Reviewer #1:

The manuscript describes use of a new citizen science dataset (snow depth) to guide simulations of SWE via data assimilation (DA). The motivation is to include observations gathered from locations in the landscape that might not be monitored otherwise. The study is focused on a maritime snow climate of Alaska. The model used (SnowModel) has a long history and is well established. A range of different observations (Snotel, field surveys with depth and SWE, and remotely-sensed snow depth) are used to gauge performance of the DA system, compared to simulations that do not include the depth observations.

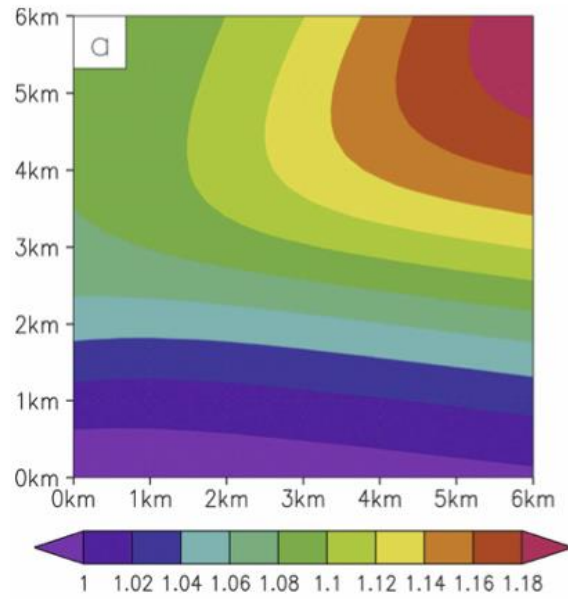
The methods section provides only a limited description of how the model is adjusted for mismatch with observations (“SnowAssim aggregates all the assimilated observations by date and creates a spatially varying correction surface that covers the entire model domain (Liston and Elder, 2008). These various correction surfaces are applied by adjusting the model precipitation fluxes and snowmelt factors between SWE observation dates during a second SnowModel simulation”). The ‘adjustments’ to the model are central to the effort, so the method should be described more completely in the manuscript.

The authors note that the literature on SnowAssim (Liston and Heimstra, 2008) is cited in the methods section 3.2.4 and we make efforts to not repeat information from that publication. First, see Figure RC1 (Figure 6a from Liston and Heimstra, 2008) included in our response below for

the reviewer's ease, as an example of a correction surface referenced above. We do not include an example of the correction surface in the manuscript because it is explained in the original literature. However, see the previous answer for additional information that will be added to the manuscript's method section 3.2.4.

Figure RC2: Snow water equivalent (SWE) time series results with measurement uncertainty included. The simulations with ± 10.5 cm of SWE represent the upper and lower boundaries of error introduced when converting snow depth measurements to SWE using the Hill et al. (2019) method.

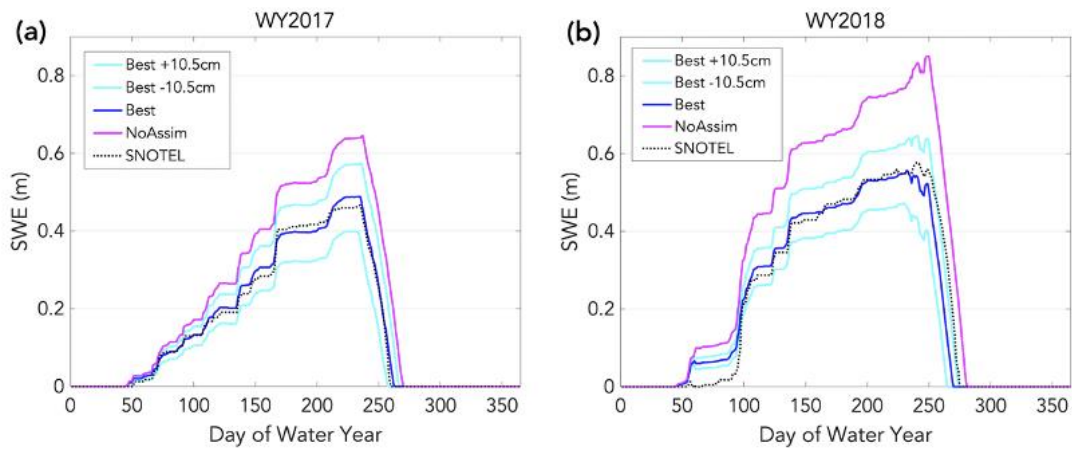
Second, uncertainty of the observations and validation data should be described and incorporated into the analysis. One of the benefits of DA is that the magnitude of uncertainty can be explicitly

The spatial representativeness of the depth measurements is mentioned in the discussion. One component of uncertainty is related to the conversion from depth to SWE, using the density estimation described in Hill (2019). In the region analyzed, SWE estimates based on density from Hill (2019) have an RMSE of 0.2-0.25 (normalized to snow season precipitation). Is this considered in the DA approach? Uncertainty (or biases) of the validation data is not described, thus it is implied that the data are ‘perfect’. What is the error or uncertainty associated with the federal sampler data?

Results in Fig 5 also seem strange. Fig 5e: how can this be the ‘best’ simulation? There is a clear problem during the ablation period; is it really a “best” simulation if ablation is too rapid? If stats are calculated throughout the season, and ablation season is short, it is easy to discount the errors during this time of year. But doesn’t timing of snow disappearance matter? Perhaps a metric of snow disappearance date should be included? One could argue the result in 5f is much worse than 5d, so that assimilation is not improving the simulations, but actually making it worse.

“Using the snow depth to SWE conversion method during assimilation introduces uncertainty into the modeling process. Instead of using the global estimates of error reported in Hill et al. (2019; RMSE in SWE = 5.9 cm) we decided to calculate this source of error using our fieldwork site

measurements. The RMSE in SWE due to the conversion method is 10.5 cm and we perturbed the CSO observations by this amount to depict the upper and lower boundaries of error associated with this source of uncertainty. Figure [RC2] displays the Best CSO simulation temporal results for each WY, along with the UTS station SWE record and the NoAssim case. These perturbations to the assimilated SWE show improved modeled SWE values at the UTS station when compared to the NoAssim case, even after this source of uncertainty has been accounted for.”

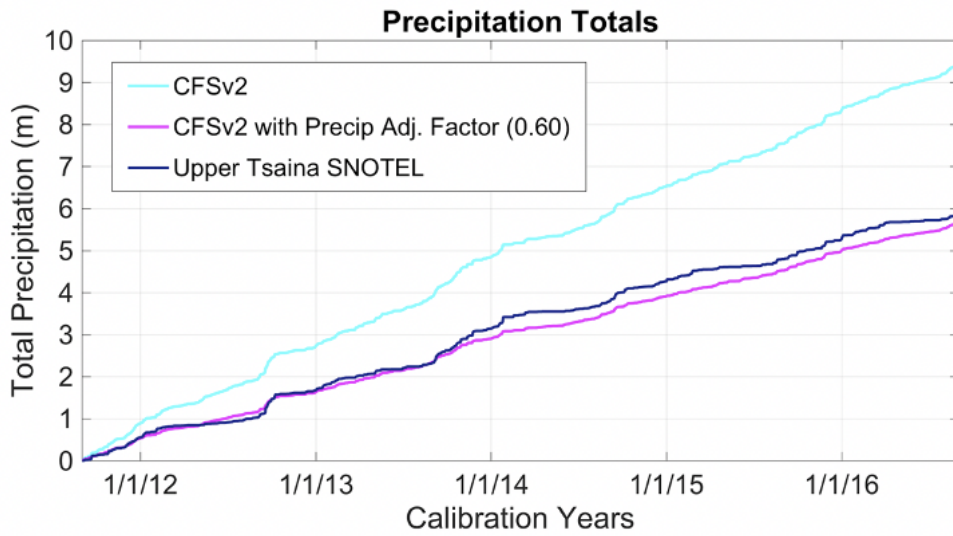
Third, something seems strange about the calibration and validation methods and results. Are the NSE values in Table 1 correct? If the best simulation has $NSE < 0$, this would suggest that the calibration is not working very well. Additional details are required.

The values in Table 1 in the manuscript are correct and they were the impetus for including the precipitation adjustment experiment in the manuscript. The initial calibration model runs and the final No Assimilation model runs were displaying time-series SWE values that were consistently high, throughout both water years, with both reanalysis products (see original Figure 5a and 5d). We know that biases in meteorological forcings are one of the most important factors in estimating snow depth and SWE magnitudes correctly (Liston and Heimstra, 2008; Margulis et al., 2015). So we decided to take a closer look at the precipitation totals with the CFSv2 product. See Figure RC3 that shows the total amount of precipitation over the calibration period when compared to the Upper Tsaina Snotel station and compared to when a precipitation adjustment factor is used. The authors would like to add this figure to the appendix to clarify the need for precipitation adjustments, whether via data assimilation or the precipitation adjustment experiment.

Because of this bias in the meteorological inputs, and after a conversation with the model developer about the calibration challenges in this region of Alaska, the authors were confident that making adjustments to the model parameters would only slightly improve our snow depth and SWE distributions and magnitudes (see Appendix A for a full list of the model parameter adjustments made during calibration). The improvements that could be made by adjusting model parameters were insignificant when compared to adjusting the precipitation fields.
